Responses to NRC Letter Dated July 17, 1998

Request for Additional Information on the Reclamation Plan for the White Mesa
Uranium Mill

Source Material License SUA-1358

Re: White Mesa Uranium Mill
Response to NRC's Questions Dated July 17, 1998
Site Reclamation Plan

ATTACHMENT 3

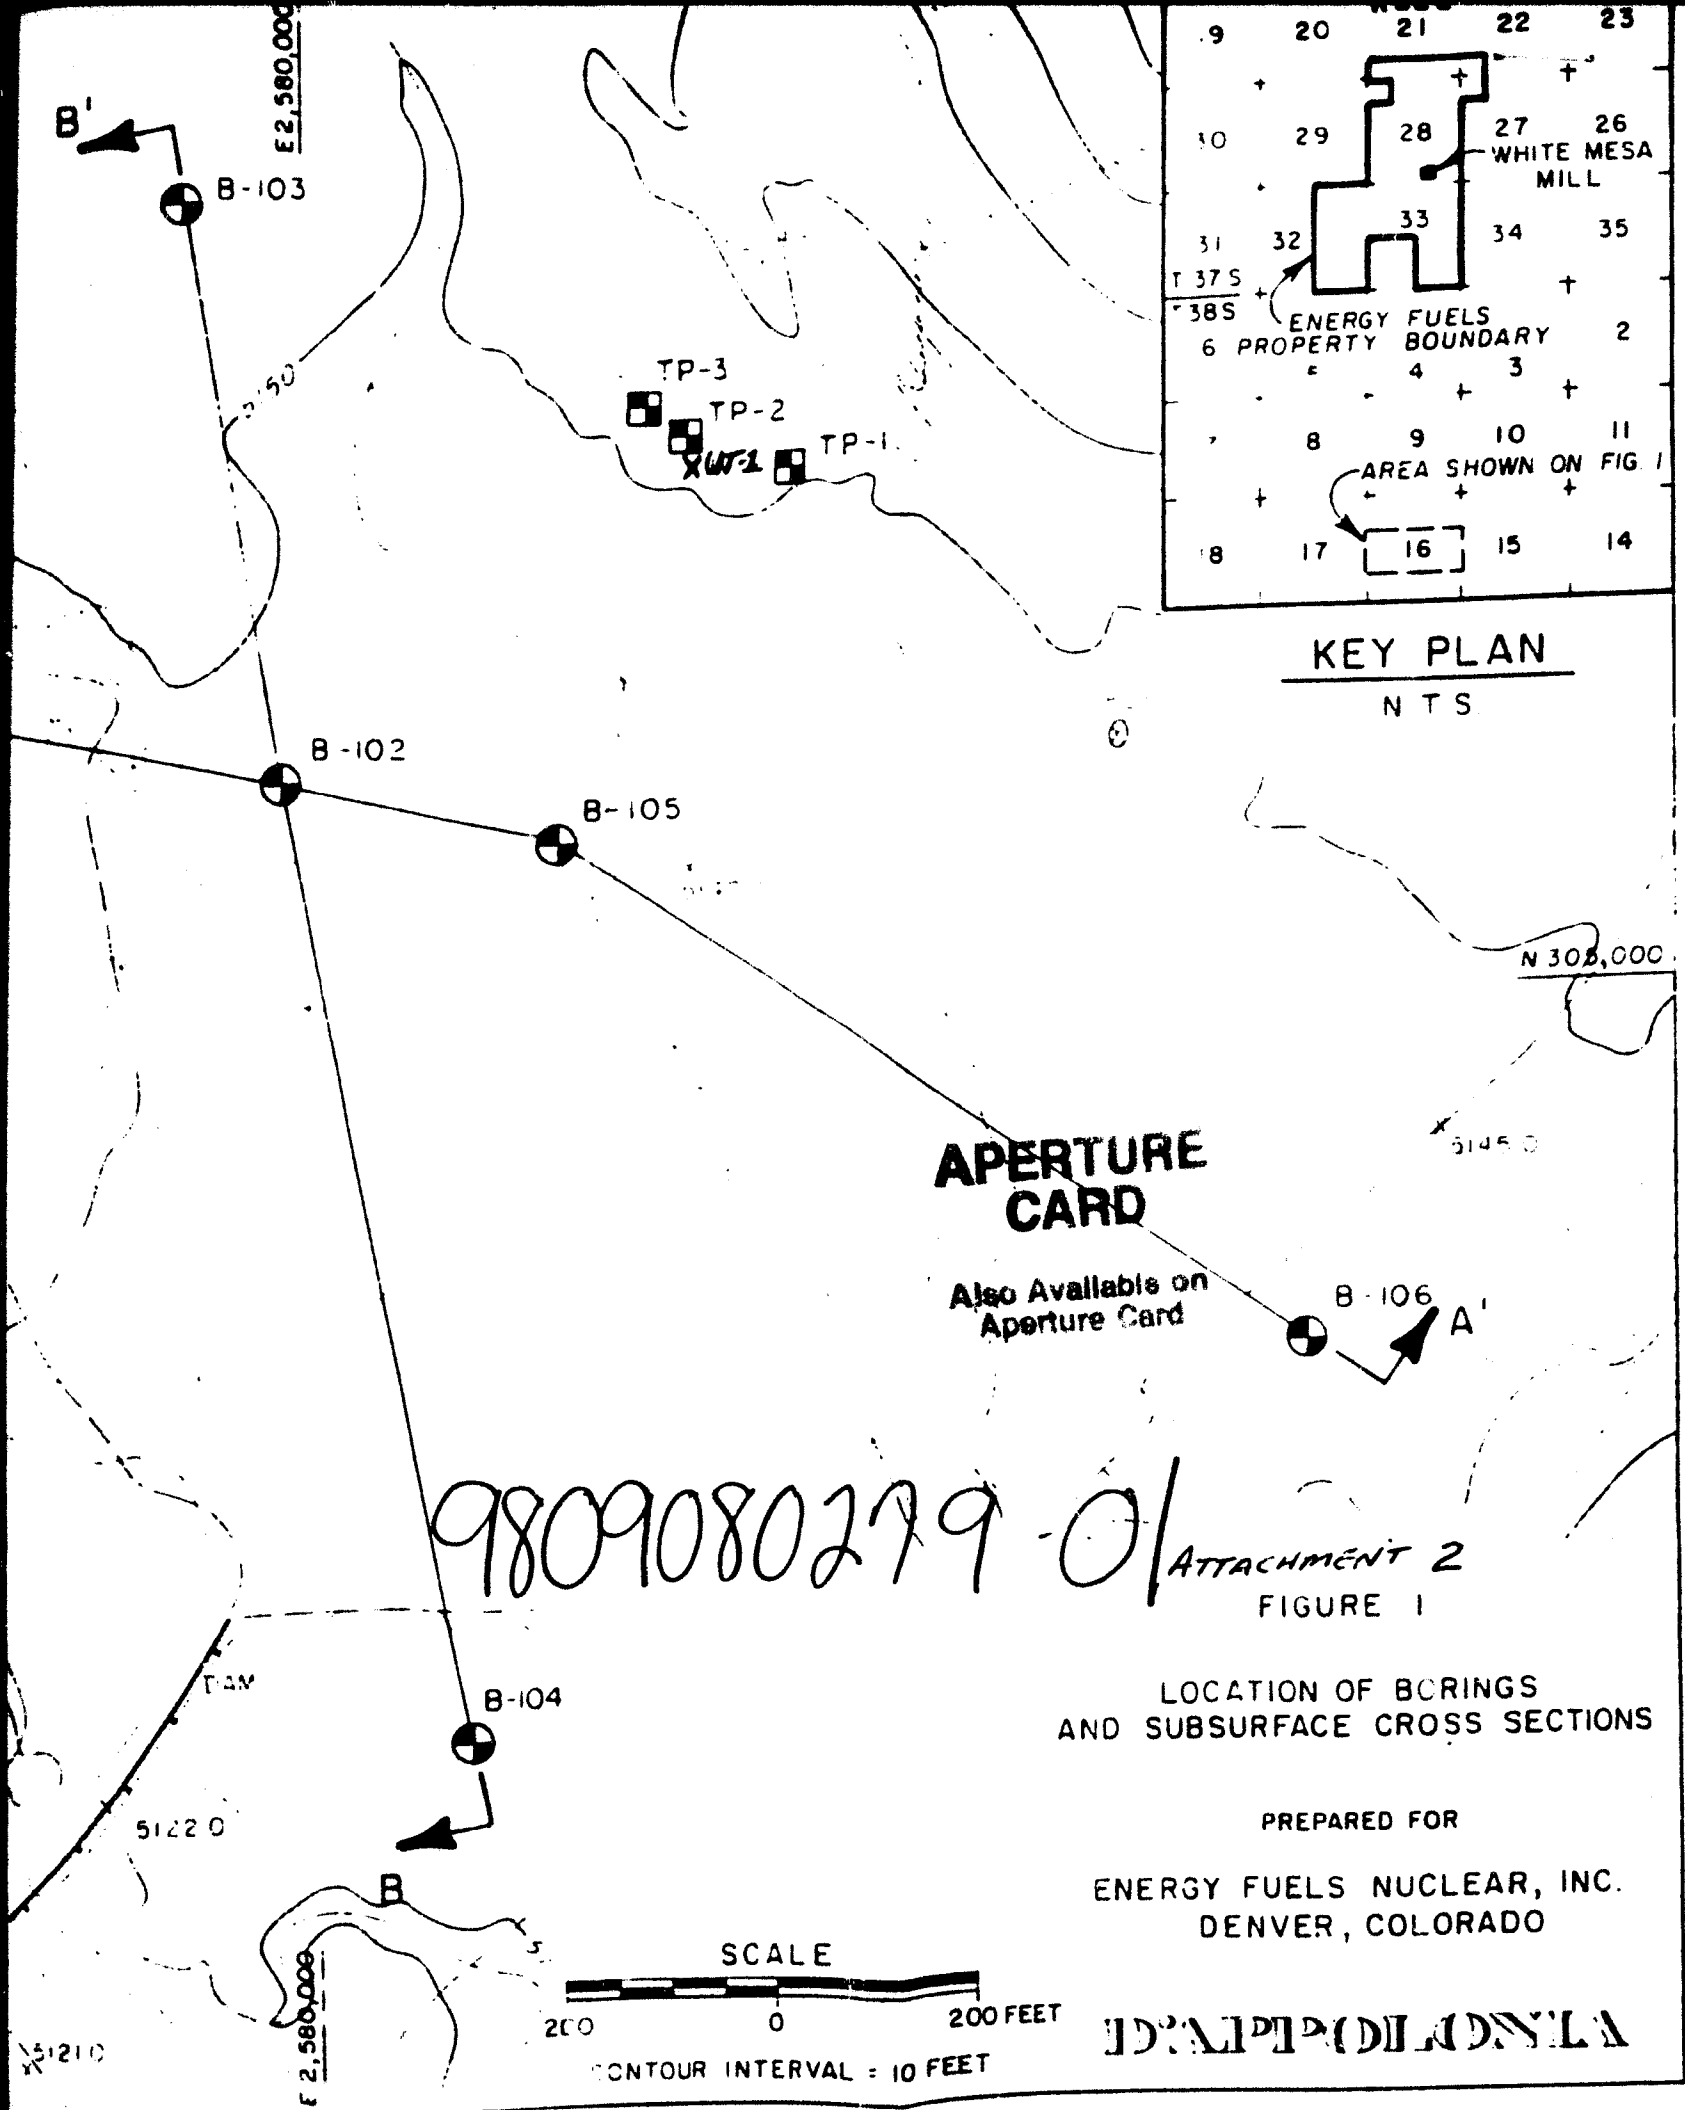
There appears to be inconsistency among the figures in Appendix G and the borehole logs from Chen & Associates given in that appendix. Without a discussion of the borehole logs and the figures, it is not possible to determine how the position of the bedrock surface was inferred from the borehole logs. For example, Figure 1 of Appendix G shows that the bedrock surface was encountered in two boreholes - Chen #29 and Chen #77. The borehole logs provided in Appendix G do not include these boreholes. If these two boreholes belong to the series of holes shown in Figure 3 (BH-15 through BH-28), then the boreholes named Chen #29 and Chen #77 cannot intersect the boundary of Cell 4. If these holes belong to the series of borehole logs given in Appendix G (Hole 1 through Hole 75), then information about borehole Chen #77 is missing.

Also, the surface elevation contours given in Figure 3 do not match the borehole logs provided. For example, according to the contours in the figure, the collar elevation of BH-

Therefore, IUSA should resolve the inconsistencies among the figures and the borehole logs and provide the missing information.

The inconsistency of drill hole data comes from an incomplete data set being provided. Drill holes designated with a BH are holes drilled by Dames and Moore while the holes drilled by Chen and Associates have no prefix. The attached copy of Appendix B from the Cell 4 design submitted to the NRC in August of 1988 (Attachment 1) provides a better explanation of drill hole series, locations, elevations and drill logs. The map included with this attachment provides an overall view of the site that better explains the locations of the various drill hole series, with corresponding collar elevations.

Concerning the specific example pointed out in this comment, the collar elevation indicated by the map contours (before the cover stockpiles were placed) for the Chen series hole 24 is between 5600 and 5610 which corresponds with the drill log collar elevation of 5609. Drill hole BH-24 (Dames & Moore drill hole 24) has a map collar elevation between 5570 and 5580, with the drill log indicating a collar elevation of 5573. The confusion comes from having two series of drill holes with similar numbering systems and only having a piece of the map without the legend. The attached information should clarify the earlier confusion.

FIGURE 2
ATTACHMENT 4

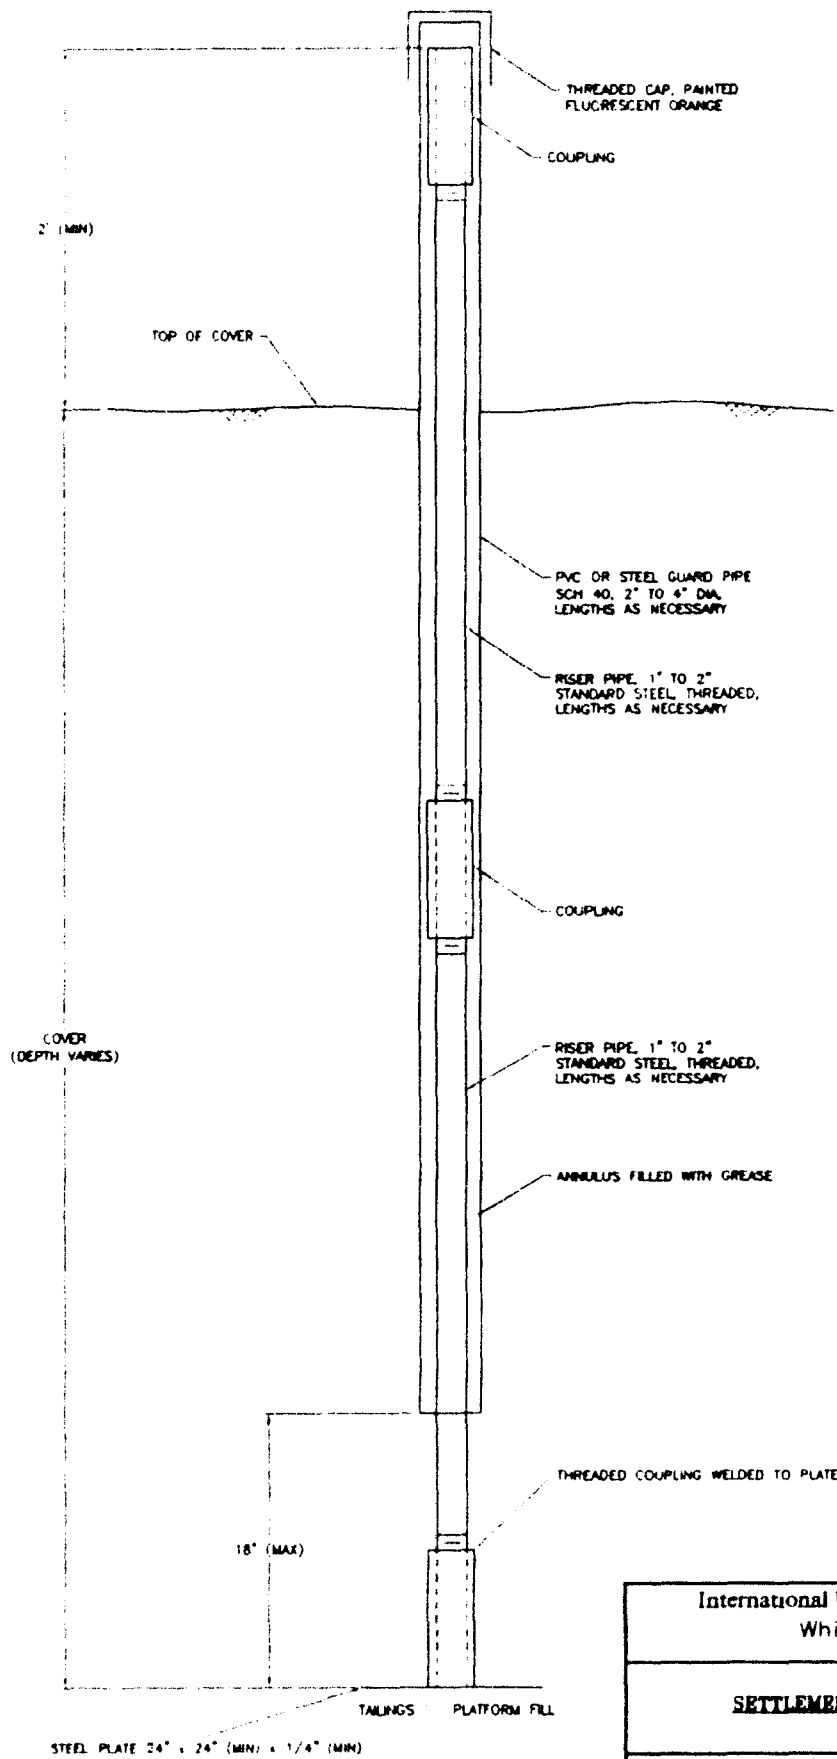
A plan for settlement measurement that is satisfactory for producing representative settlement data throughout the disposal cells is required. Settlement measurement stations should be of sufficient coverage and should be strategically placed to yield adequate information for determination of differential and residual settlements. Monitoring monuments should be designed to be durable.

Settlement monitors are monitored on a monthly basis utilizing standard surveying practices for vertical control. All elevations are referenced to an established benchmark located on solid ground away from the tailings cells. Settlement for each point is tracked utilizing a spreadsheet program and graphs. Figure 2 of Attachment 4 represents the design of the settlement monitors.
